**CITY OF MERIDIAN
FINDINGS OF FACT, CONCLUSIONS OF LAW
AND DECISION & ORDER**

Case No(s). H-2025-0059 (CPAM); H-2026-0007 (AZ, PP)

COMMUNITY DEVELOPMENT DEPARTMENT REPORT

SUBJECT: Ustick Commercial and McUstick Subdivision
H-2025-0059 (CPAM); H-2026-0007 (AZ, PP)

USTICK RD. LANDSCAPE BUFFER SECTION

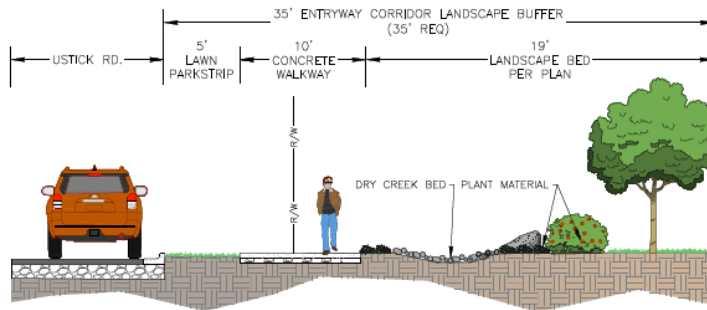
Landscaping must comply with the standards in UDC 11-3B-7C. **Lawn and other grasses requiring regular mowing shall comprise no more than sixty-five (65) percent of the vegetated coverage of a landscape buffer; calculations demonstrating compliance should be included on the plan.** Because W. Ustick Rd. is an entryway corridor, additional landscape design features are required within the buffer as set forth in UDC 11-3B-7C.3f. The additional design features consist of a dry creek bed with river rock and boulders as shown on the cross-section below and on the landscape plan below in Section VII.H.

- ii. Lawn and other grasses requiring regular mowing shall comprise no more than sixty-five (65) percent of the vegetated coverage of a landscape (street) buffer per UDC 11-3B-7C.3e; calculations or a note demonstrating compliance should be included on the plan.

E. Conceptual Development Plan

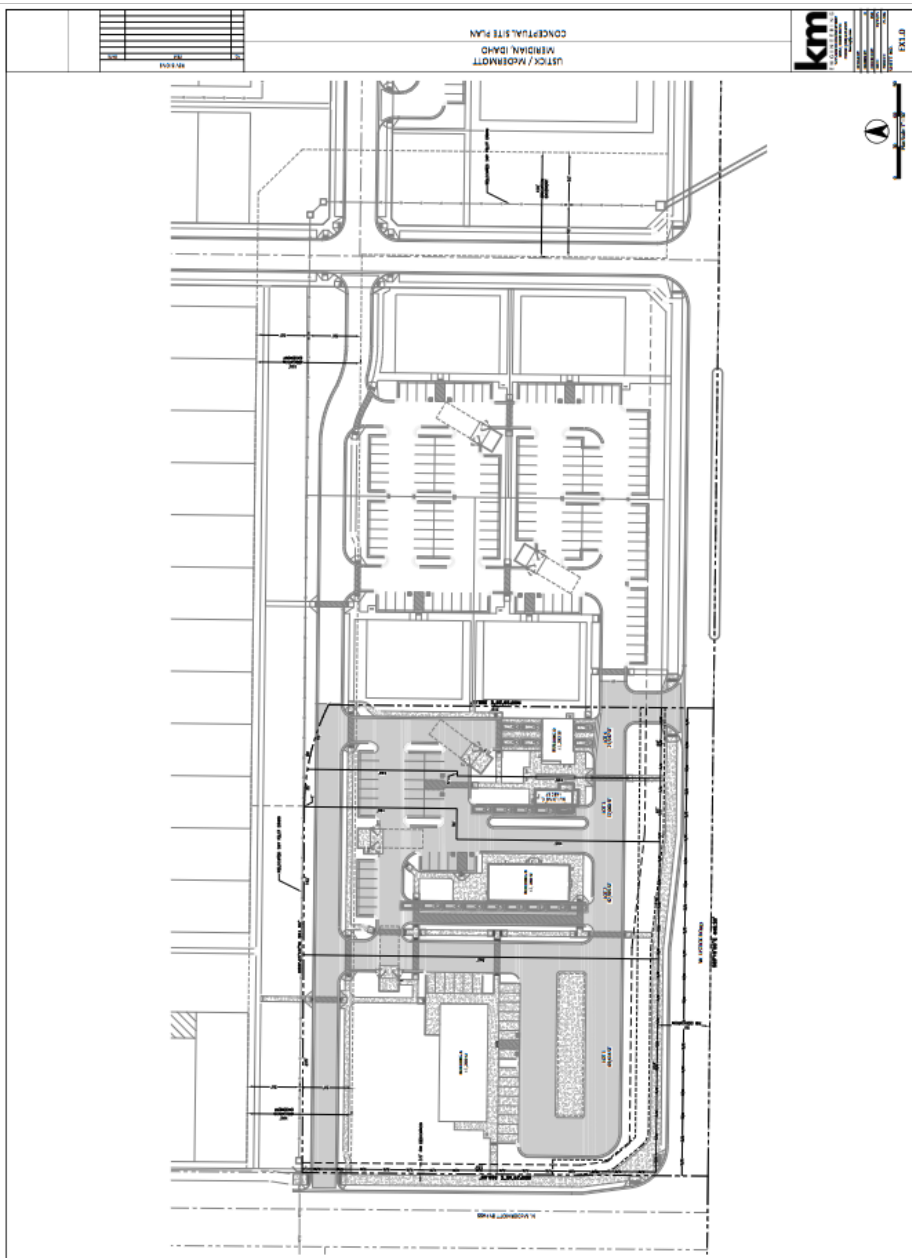
The conceptual development plan depicts an interconnected network of walkways and drive aisles that promote pedestrian and vehicular mobility within the development and to the adjacent development to the east; a pathway is proposed to the future residential development to the north for pedestrian access and connectivity, no vehicular connectivity is proposed.

For lots with frontage on a public street, a minimum of thirty (30) percent of the buildable frontage of the property shall be occupied by building facades and/or public space per UDC 11-3A-19B.2b. A drive aisle is proposed along the frontage of the property adjacent to Ustick Rd., which separates the buildings from the street – parking is proposed at the rear of the buildings. **If the proposed development is approved, compliance with this standard is required. A revised conceptual development plan should be submitted that demonstrates compliance with this standard.**

Drive aisle stubs are proposed to the property to the east but no vehicular connectivity is proposed to the future residential development to the north. **If approved, Staff recommends a drive aisle connection be provided to the north for interconnectivity with the residential neighborhood. Cross-access/ingress-egress easements are required between all lots in the subdivision and to adjoining properties either by recorded easement or as a note on the final plat as set forth in UDC 11-3A-3A.2.**

- i. Future development of this site shall be generally consistent with the conceptual development plan and building elevations, preliminary plat, landscape plan, and buffer exhibits included below in Section VII and the provisions contained herein. One of the two conceptual drive-throughs may be a Tier 3 subject to conditional use permit approval by City Council.

H. Landscape Plan and Buffer Exhibit (date: 12/15/2025)

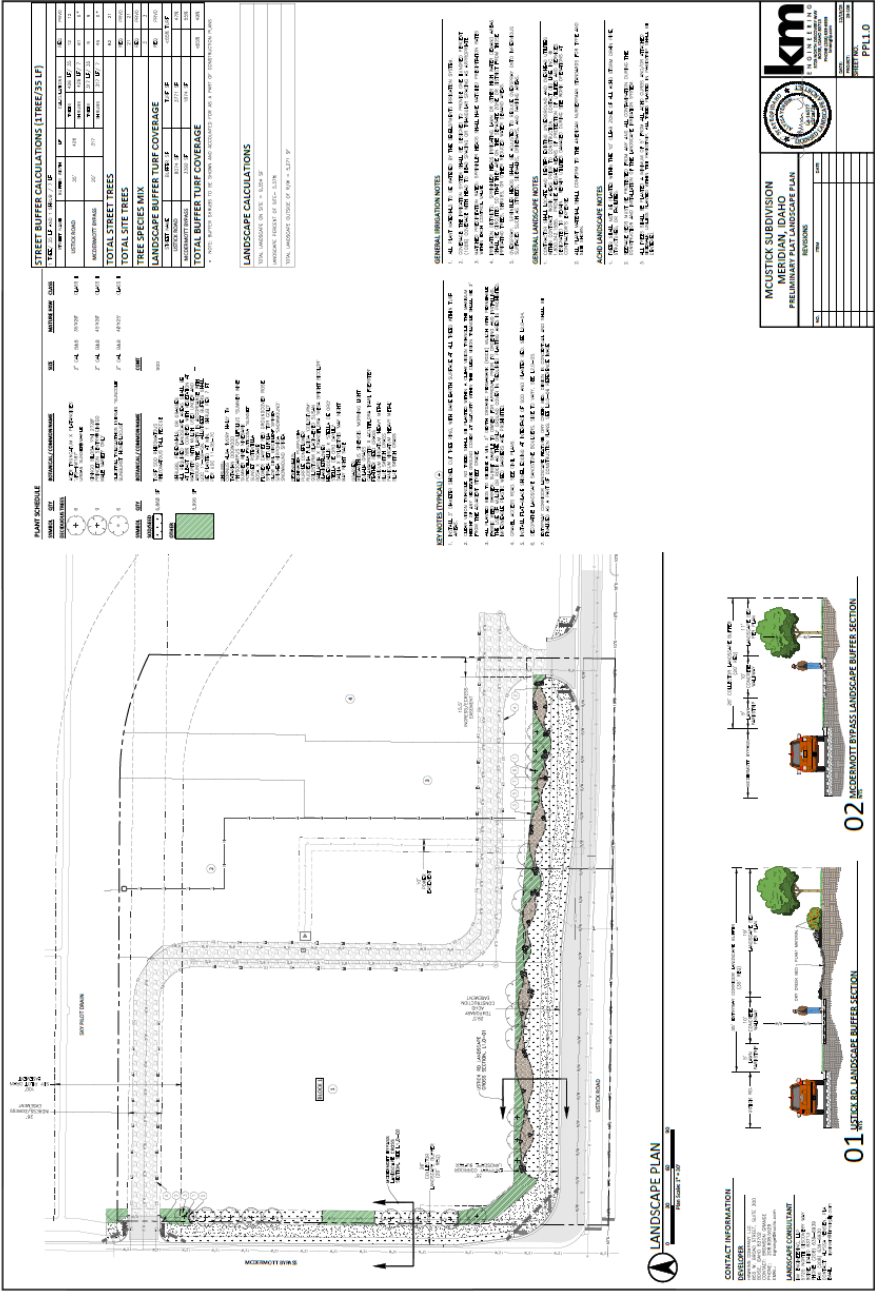
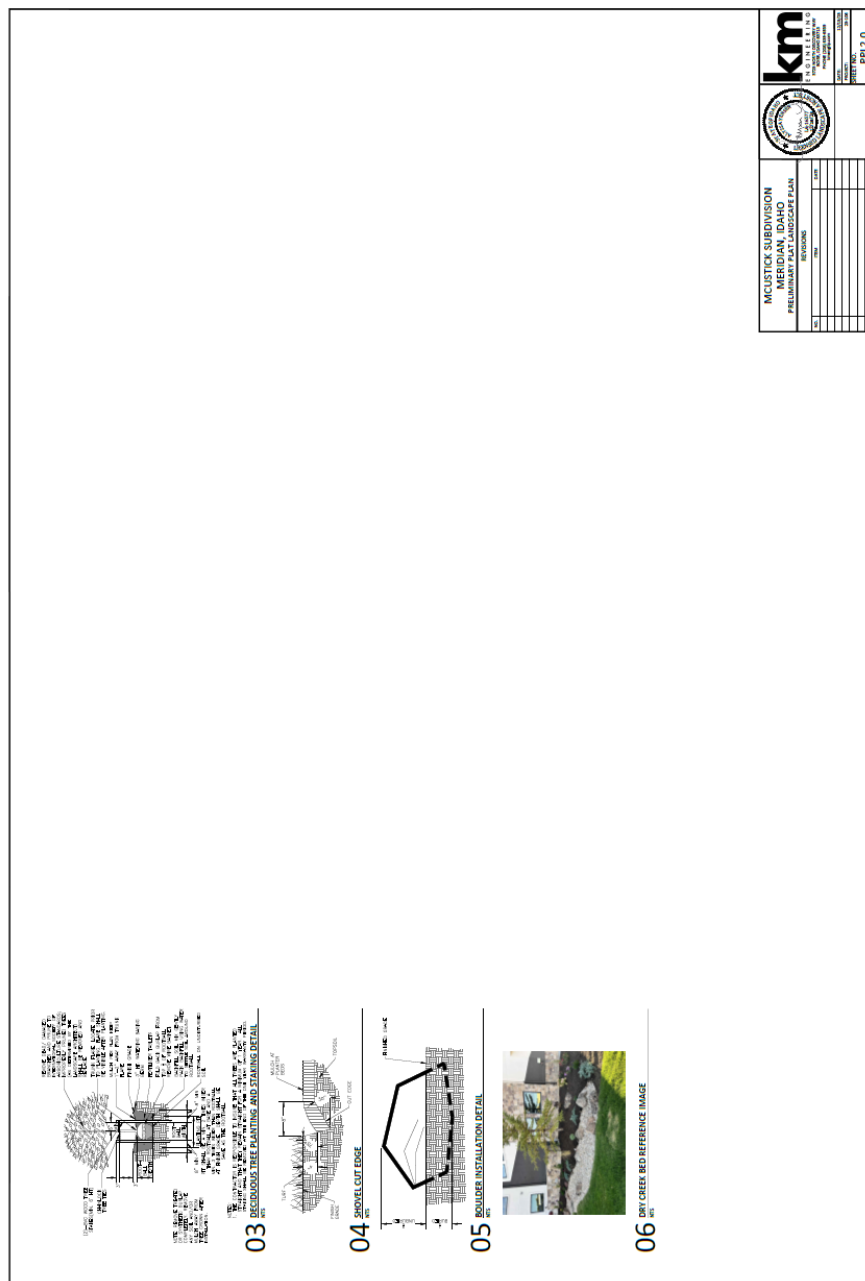
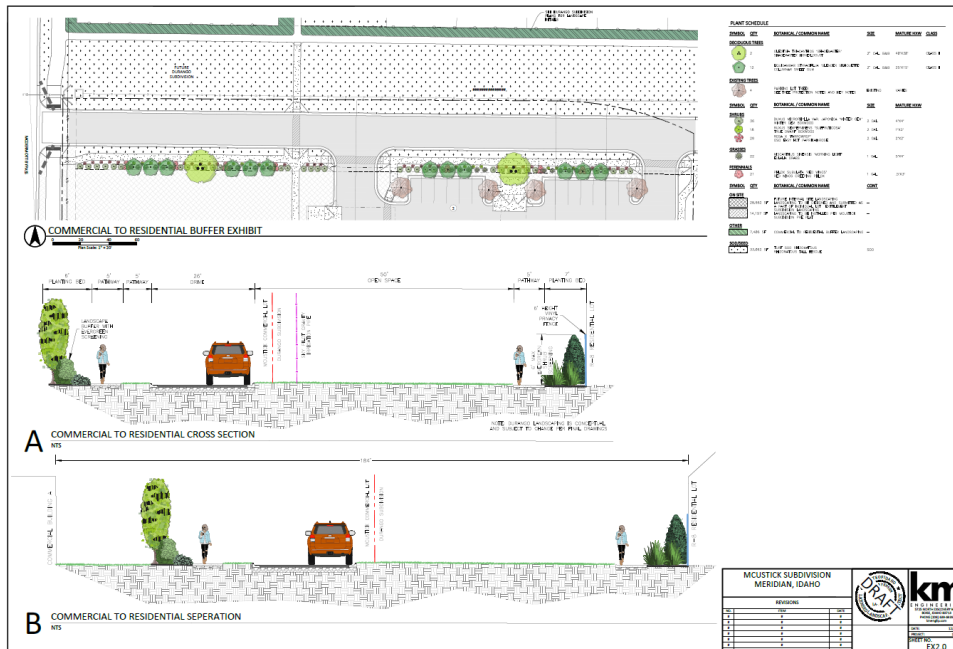
Because there is a 50' wide easement for the Sky Pilot Drain along the north property boundary, which prohibits trees/shrubbery, the buffer should be placed outside of the

easement. **The width of the buffer may be modified by City Council at a public hearing with notice to surrounding property owners if requested by the Applicant.**

There are existing trees on the site that will be removed with development. **Mitigation should be assessed prior to removal of any trees from the site and information should be included on the landscape plan that demonstrates compliance with the standards in UDC 11-3B-10C.5.**

3. The landscape plan submitted with the final plat application(s) shall include the following revisions:
 - i. Where pedestrian pathways are proposed from perimeter sidewalks to the main building entrances, pathways shall be distinguished from vehicular driving surfaces through the use of pavers, colored or scored concrete, or bricks, per UDC 11-3A-19B.4b.
